Design Review Subcommittee (DRSC)

Meeting Date: December 12, 2018

SUBJECT: **Conditional Use Permits 18-529, -530, -531, -532, -533, -534, -535, -536, -537, -538, -540, -541, -543, AT&T Small Cells in Right-of-Way,** review of design alternatives for a request to construct 13 “small cells” on street lights and utility poles within the public right-of-way at 13 locations throughout the City, previously reviewed by the DRSC.

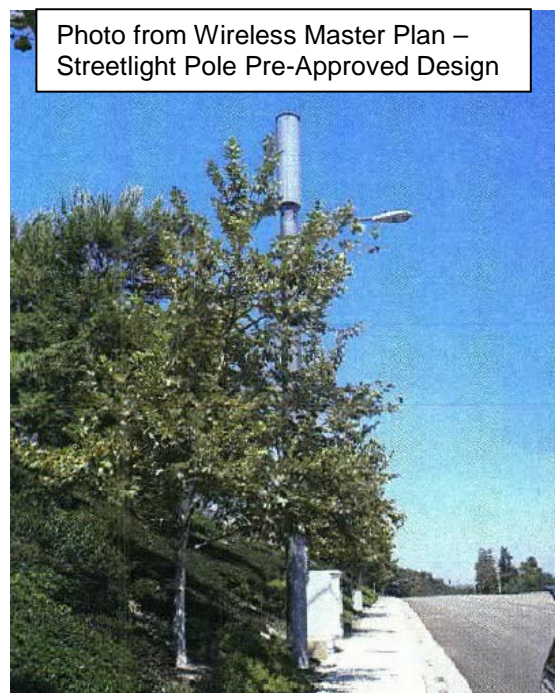
During DRSC discussion, one DRSC member expressed a preference for a tapered pole design for Type 1 installations, as opposed to the design presented. The DRSC did not reach a consensus and expressed interest in reviewing a tapered design option before making a recommendation on the preferred Type 1 design. Additionally the DRSC expressed interest in seeing a Type 2 design with the antenna at the top of the pole and the associated equipment and radios mounted closer to the pole.

STEEL UTILITY POLE W/ ANTENNA TOP MOUNTED

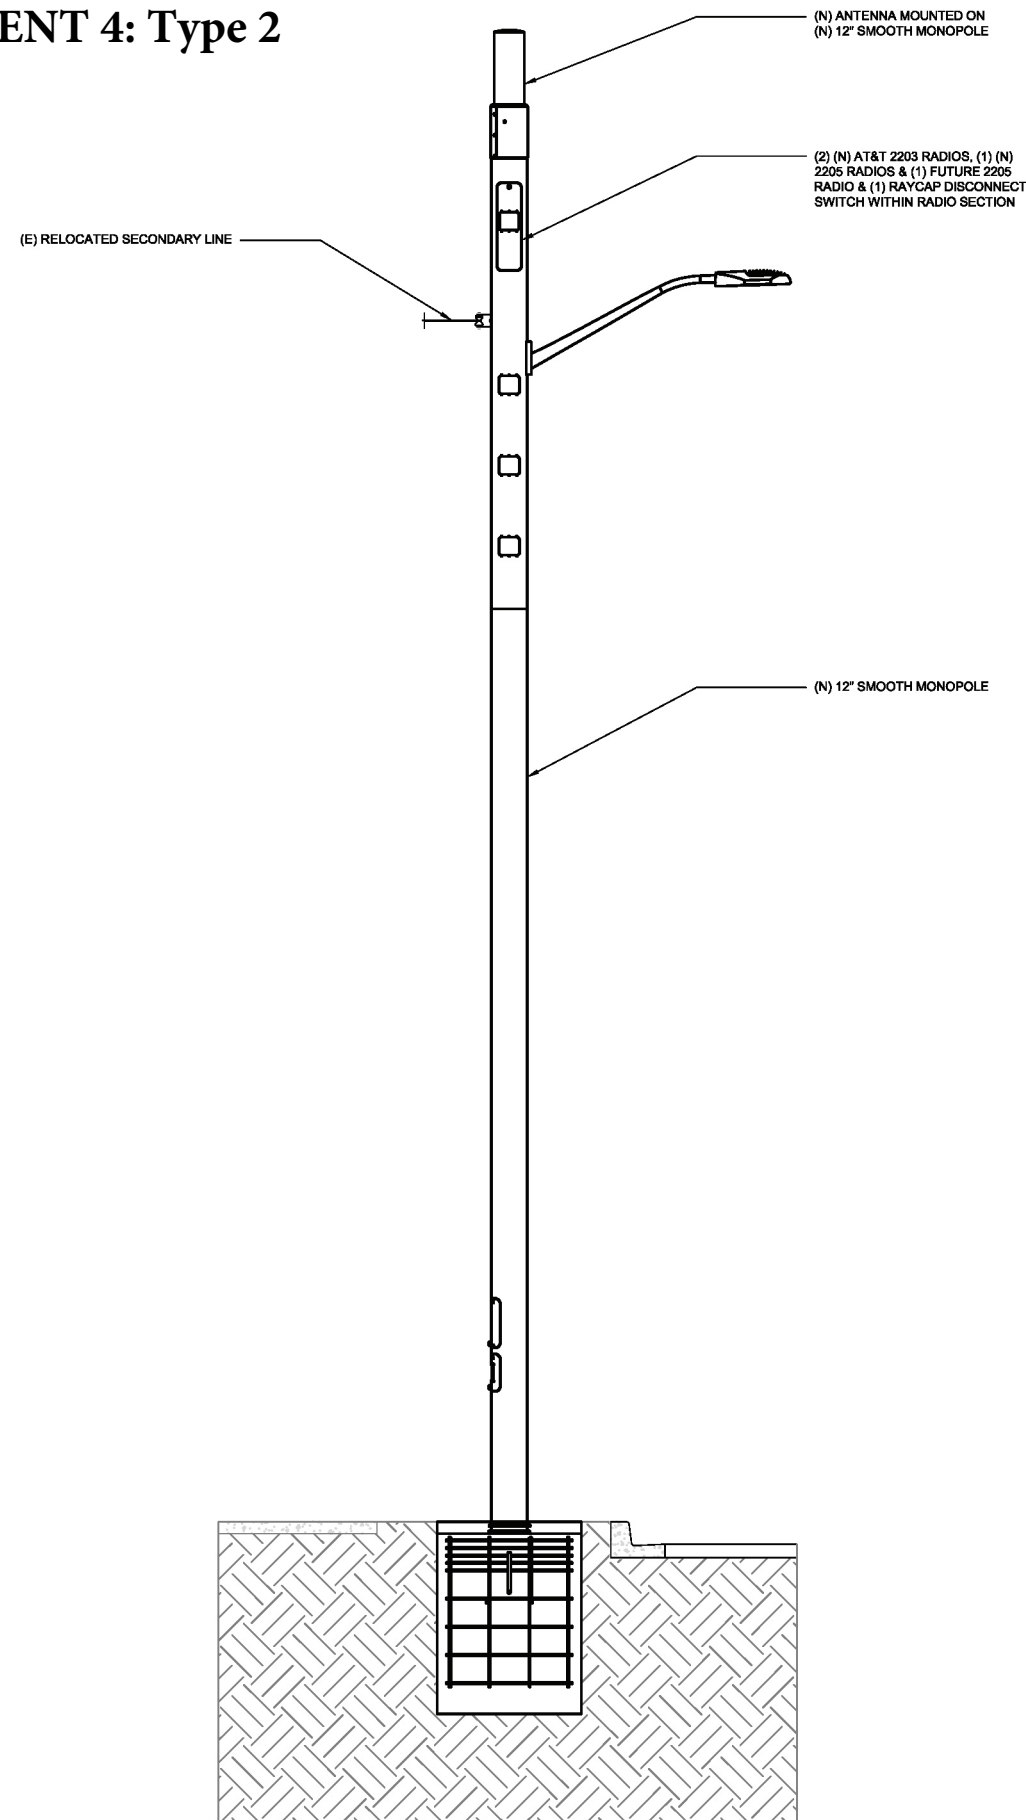
- Noted inconsistencies between how Type 2 installations were shown on the plans and the photo simulations.
- Recommended for Type 2 installations that cannot be relocated to Type 1 installations moving the antenna to the top of the pole and mounting the radios and other equipment closer to the pole.
- Inquired about maintaining a tapered pole design, understanding that the antenna and equipment at the top would be wider than the top of the pole. The Subcommittee members did not come to a consensus regarding this option and expressed a desire to see this brought back as an option for further DRSC review.
